The Norfolk County Council (Norwich Northern Distributor Road (A1067 to A47(T))) Order

Position Statement on Landowner Raised Issues

PINS Reference Number: TR010015

Document Reference: NCC/EX/57

1.1. Plot 1/20: Mr & Mrs Savage

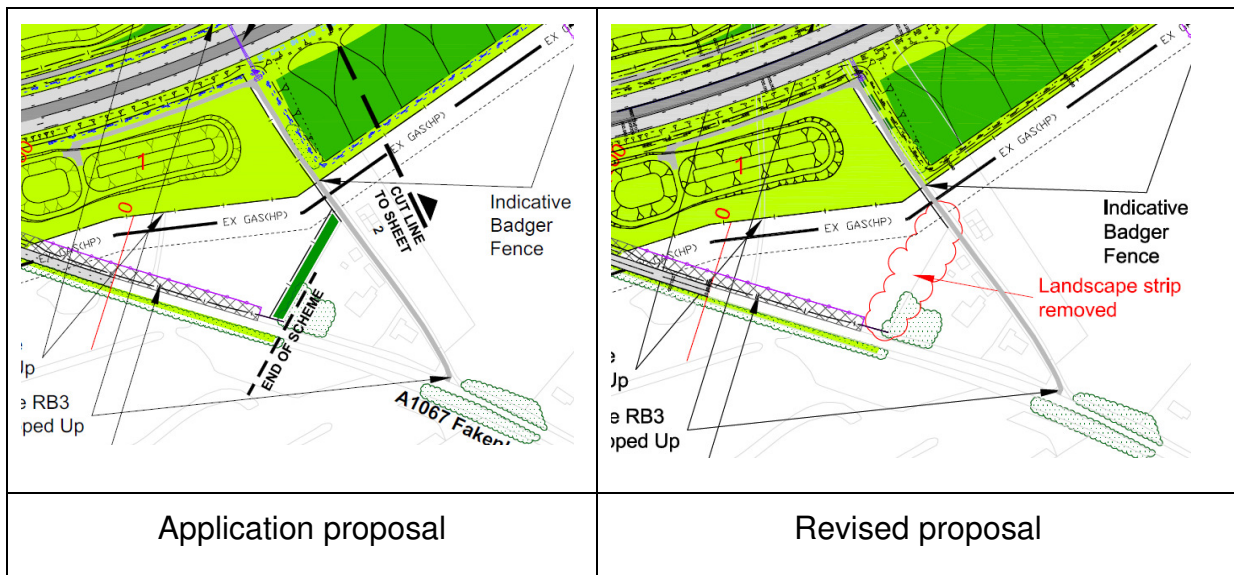
Representation: Having reviewed the plans provided to our clients we ask that the tree planting highlighted under land parcel 1/20 be removed from this scheme. My clients have no wish to lose land in their view unnecessarily and are happy with the existing tree planting that forms part of the immediate grounds to their property.

1.1.1. The Applicant has considered the request and concluded that the landscaping area (i.e. Plot 1/20 as a whole) can be removed, as requested by the landowners. This is not considered to be a material change to the Scheme and nor does it change the assessment of environmental impacts or the environmental mitigation proposals.

1.1.2. The change is identified on the General Arrangement extract below:

1.2. Plot 2/5: Mr & Mrs Arnold

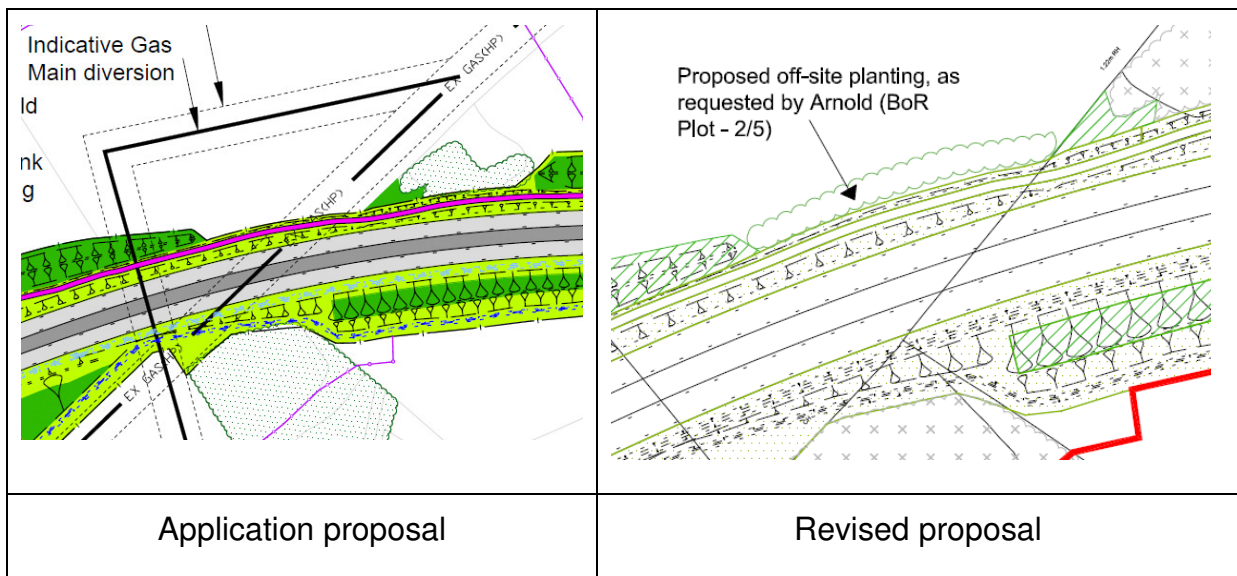
Representation: “more landscaping planting along the northern boundary of the NDR.”

- 1.2.1. The Applicant has provided the landowner’s representative with a plan identifying an additional landscaping area for their consideration. This is not considered to be a material change to the Scheme and nor does it change the assessment of environmental impacts.
- 1.2.2. It would require land, from the landowner, which is outside the Application DCO boundary.
- 1.2.3. The proposal is identified on the plan extracts below:

1.5. Plot 2/20: Trustees of the Gurloque Settlement

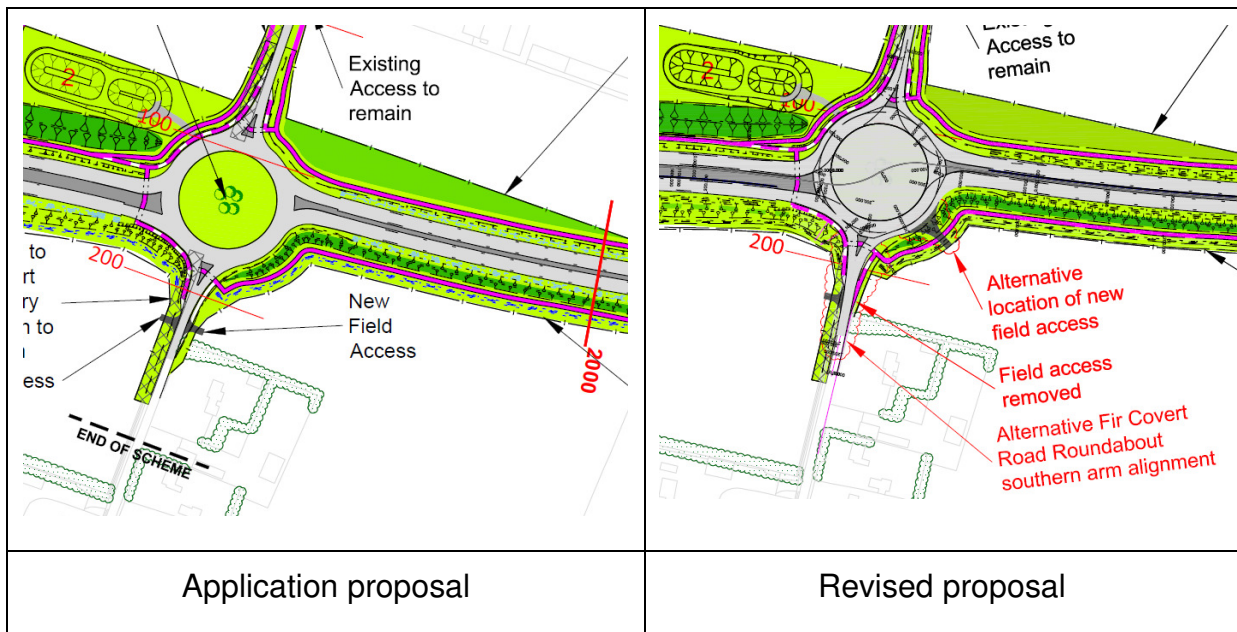
Representation: *The owners would prefer access directly from the roundabout.*

1.5.1. The Applicant has considered the request and concluded that the access (ref X7 on the Street Plans) can be moved from Fir Covert Road to directly off Fir Covert Roundabout, as requested by the landowners. This is not considered to be a material change to the Scheme and nor does it change the assessment of environmental and safety impacts.

1.5.2. The change is identified on the General Arrangement extracts below:

1.8. Plot 4/16 and 4/18: David Pulling / Paul Clarke & Mr & Mrs Palmer

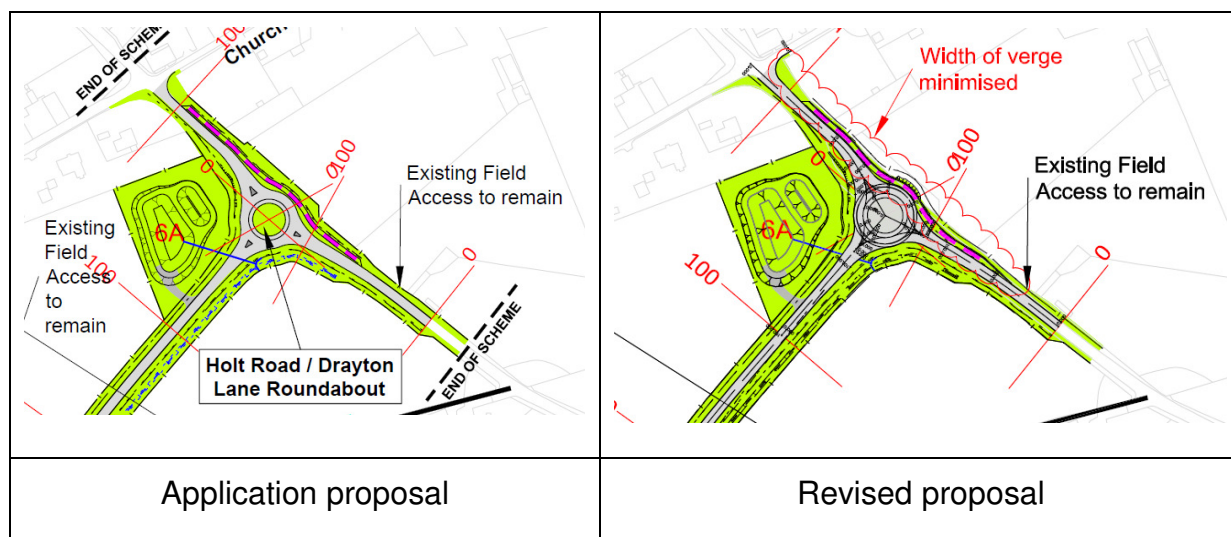
Issue: Request to investigate reduction in land take area.

1.8.1. The Applicant has carried out further detailed survey and design work and concluded that the area of land acquisition can be reduced, as requested by the landowners. This is not considered to be a material change to the Scheme and nor does it change the assessment of environmental and safety impacts.

1.8.2. The change is identified on the General Arrangement extracts below:

1.10. Plot 4/22: Mr & Mrs Keeley

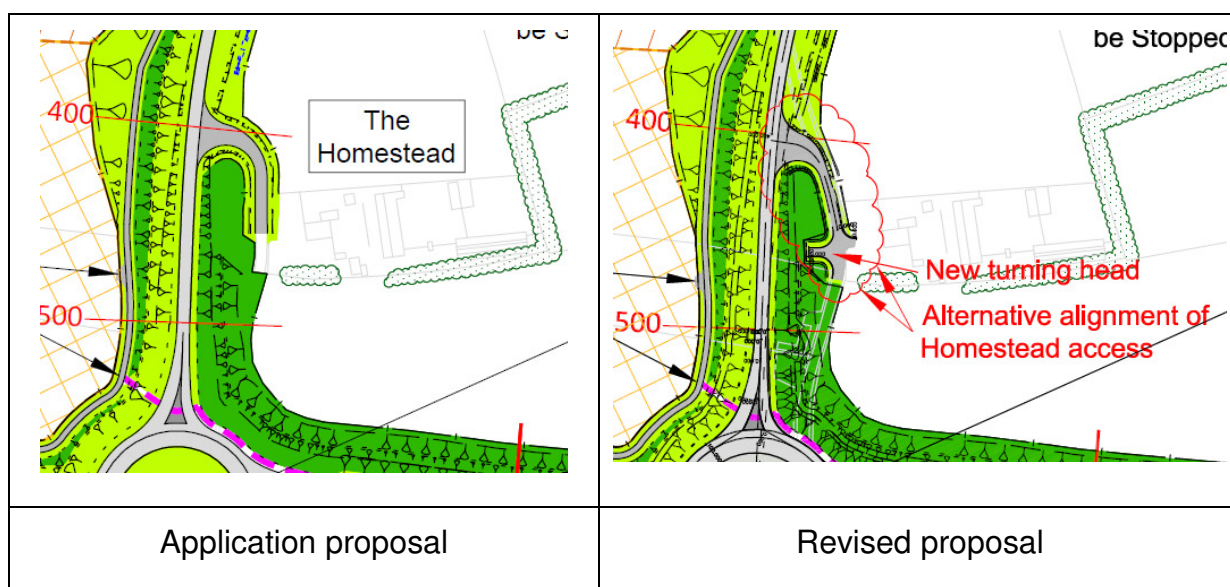
Issue: Access to The Homestead, off Drayton Lane.

1.10.1. The Applicant has carried out further detailed survey and design work to the proposed access to The Homestead, off Drayton Lane. This is not considered to be a material change to the Scheme and nor does it change the assessment of environmental and safety impacts. The change will mean that the area of land acquisition from The Homestead will be reduced.

1.10.2. The change is identified on the General Arrangement extracts below:

1.11. Plot 4/26: Mrs Rachel Foley (beneficiary of Anne Pollock deceased)

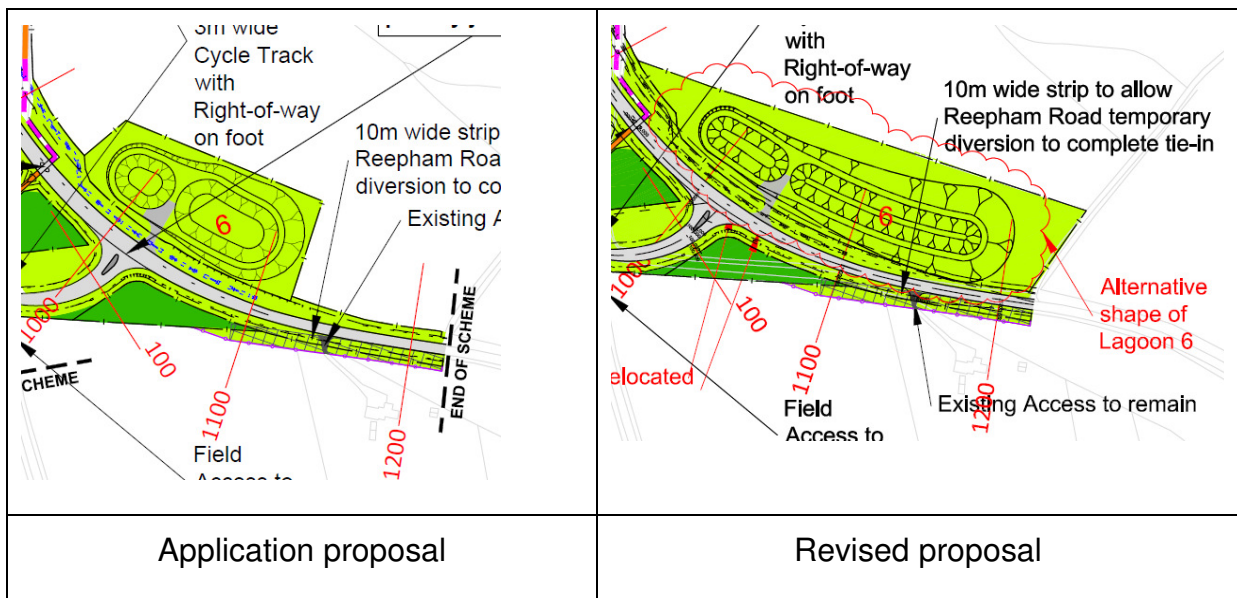
Representation Summary: Request for redesign of Lagoon 6.

1.11.1. The Applicant has provided the landowner’s representative with an amended lagoon design for their consideration. This is not considered to be a material change to the Scheme and nor does it change the assessment of environmental impacts.

1.11.3. The proposal is identified on the General Arrangement extracts below:

1.14. Plot 7/12: Patrick Douglas Cook and Alfred Peter Cook

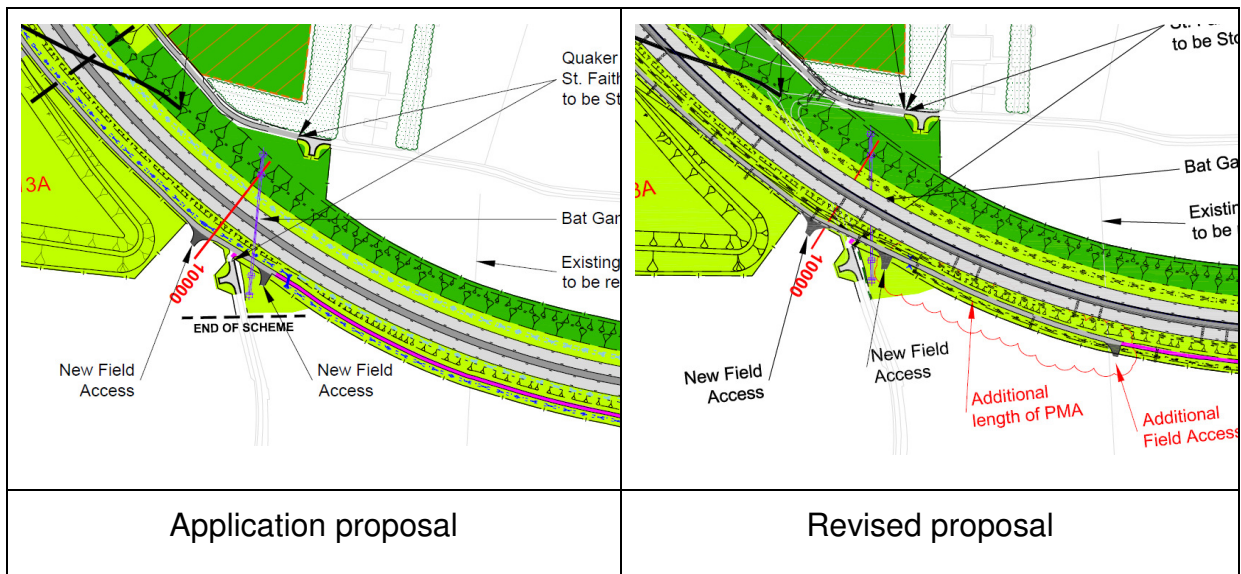
Issue: Landowner has requested an extension to the length of PMA south of the NDR, east of St Faiths Lane.

1.14.1. Through ongoing discussions with the landowner the Applicant has considered the request by the landowners and concluded that the existing shared use bridleway and PMA (ref AA and X31 on the Street Plans) can be extended a further 230m eastwards. A new field access will also need to be provided at the end of this extension. This will provide a means of access to the southern portion of a field, which is severed by the NDR and whose existing access point is off Quaker Lane to the north. This is not considered to be a material change to the Scheme and nor does it change the assessment of environmental or safety impacts.

1.14.2. The change is identified on the General Arrangement extracts below:

1.15. Plots 7/32 and 7/33 Hilary Barratt and Michael Dewing on behalf of the Trustees of the Beeston Estate

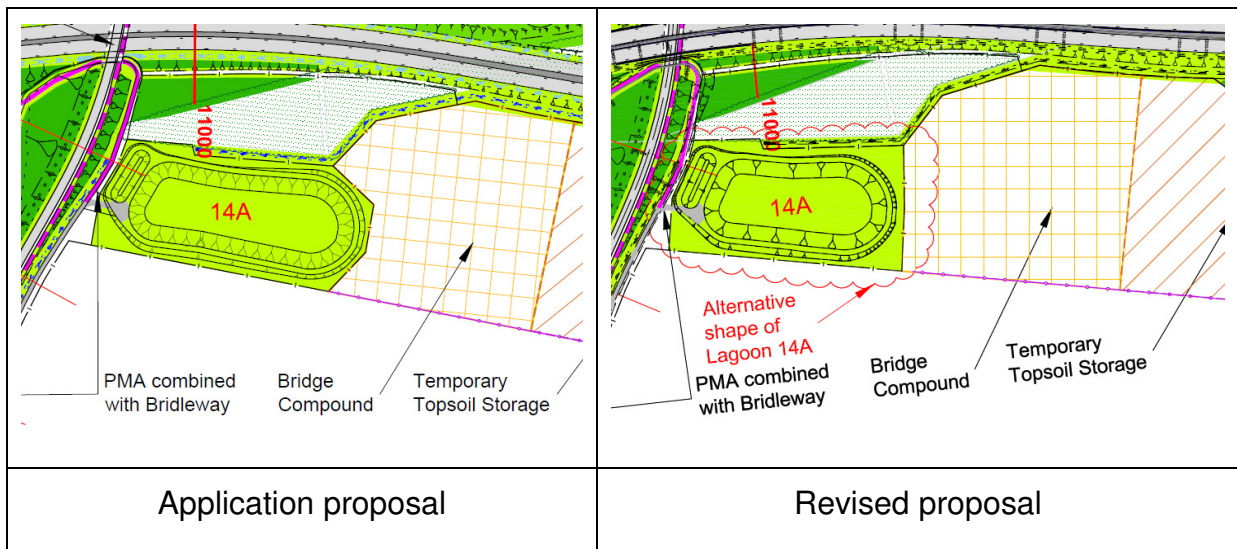
Representation summary: Request for redesign of Lagoon 14A.

1.15.1. The Applicant has provided the landowner’s representative with an amended lagoon design for their consideration. This is not considered to be a material change to the Scheme and nor does it change the assessment of environmental impacts or the environmental mitigation proposals.

1.15.2. The change is identified on the General Arrangement extracts below:

1.18. Plot 9/22

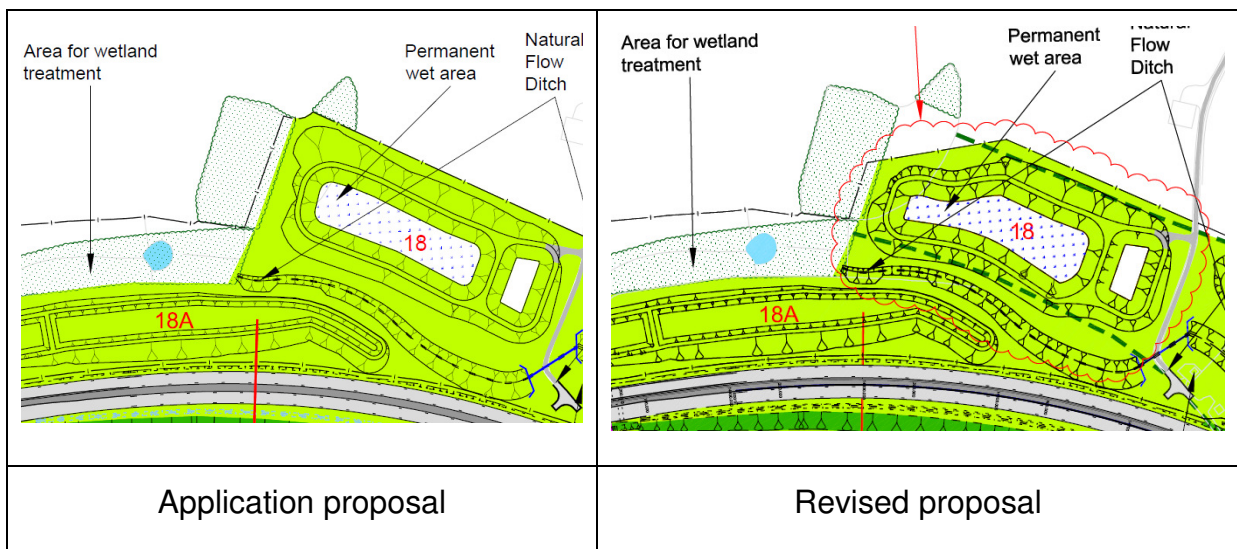
Issue: *Redesign of Lagoon 18 following comments from Local Impact Report.*

1.18.1. Following the comments about the impact on Ortlan's Grove, an ancient semi-natural woodland, in paragraph 8.3 of the Joint Broadland District Council, Broads Authority, Norfolk County Council, Norwich City Council and South Norfolk Council Local Impact Report, the Applicant has investigated an amended lagoon design to avoid the woodland. This is not considered to be a material change to the Scheme and nor does it change the assessment of environmental impacts or the environmental mitigation proposals.

1.18.2. The change is identified on the General Arrangement extracts below:

1.19. **Plots 9/24 and 9/25: Karl Basey**

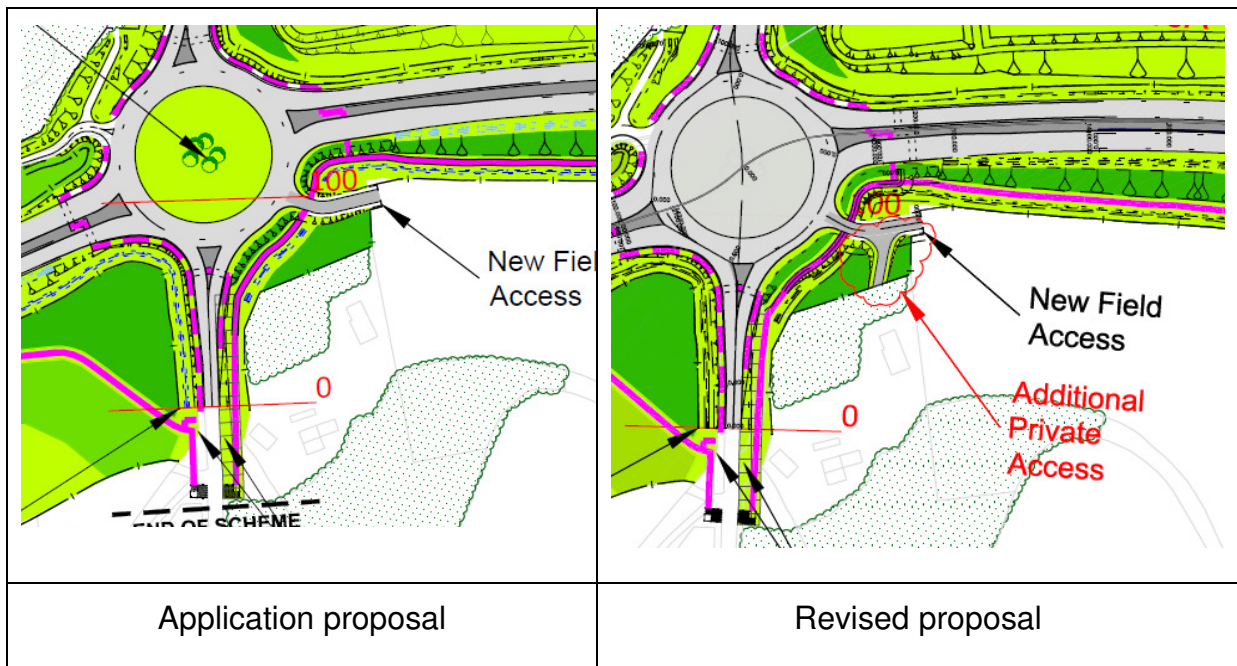
Representation: We have tentatively agreed that a private access will be taken from the roundabout into the property.

1.19.1. The Applicant has considered the request and concluded that an access can be provided from the PMA off Wroxham Road Roundabout, as requested by the landowners. This is not considered to be a material change to the Scheme and nor does it change the assessment of environmental or safety impacts.

1.19.2. The change is identified on the General Arrangement extracts below:

1.20. Plot 9/34: Blanmar 1 and Blanmar 2

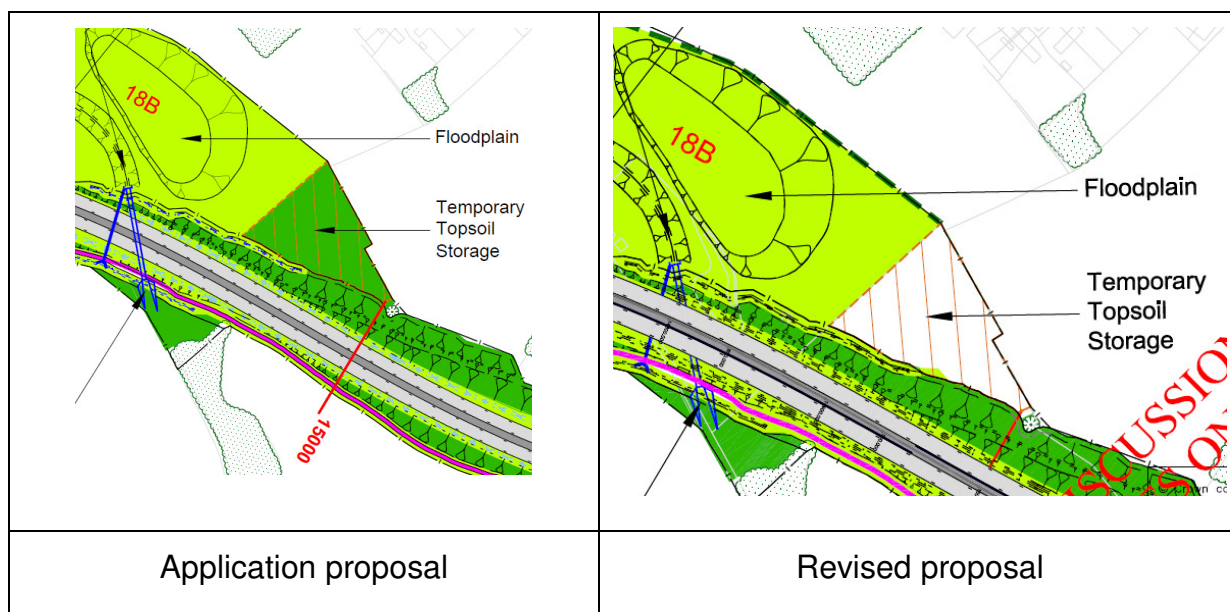
Representation: *Blanmar reject permanent acquisition, notwithstanding that access will not be provided, but would accept the temporary use for topsoil storage.*

- 1.20.1. In addition to temporary topsoil storage Plot 9/34 was also identified as new woodland creation and as a result the Applicant sought permanent acquisition.
- 1.20.2. Following the receipt of further information from the Landowner regarding a joint venture they have entered into with an adjoining owner the Applicant has reconsidered the removal of the woodland creation and permanent acquisition request.
- 1.20.3. The Applicant has concluded that the landscaping area (i.e. Plot 9/34 as a whole) can be removed, as requested by the landowners. This is not considered to be a material change to the Scheme and nor does it change the assessment of environmental impacts or the environmental mitigation proposals.
- 1.20.4. The temporary use of the Plot for top soil storage is still required and accepted by the Landowner.

1.20.5. The change is identified on the General Arrangement extracts below:

1.21. Plot 10/14 & 10/15: John Duncan & Trevor Shaw

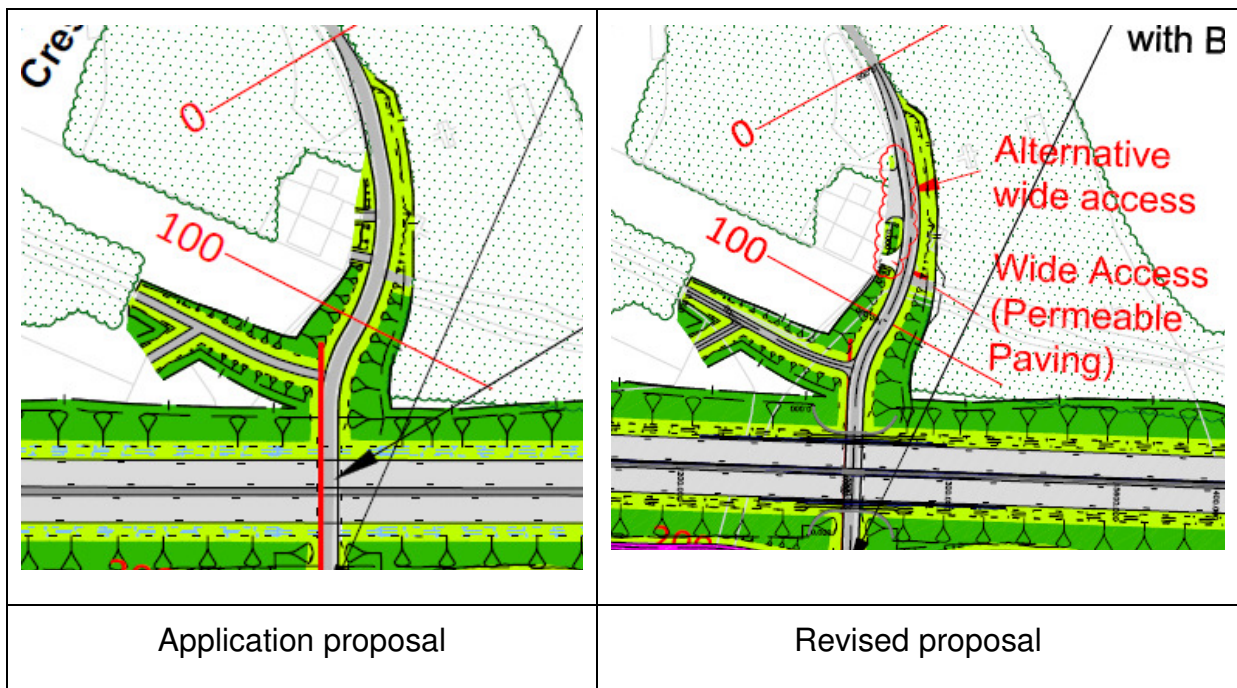
Issue: Access to property off Newman Road.

1.21.1. The Applicant has carried out further detailed survey and design work to the proposed access to industrial units, off Newman Road. This is not considered to be a material change to the Scheme and nor does it change the assessment of environmental and safety impacts.

1.21.2. The change is identified on the General Arrangement extracts below:
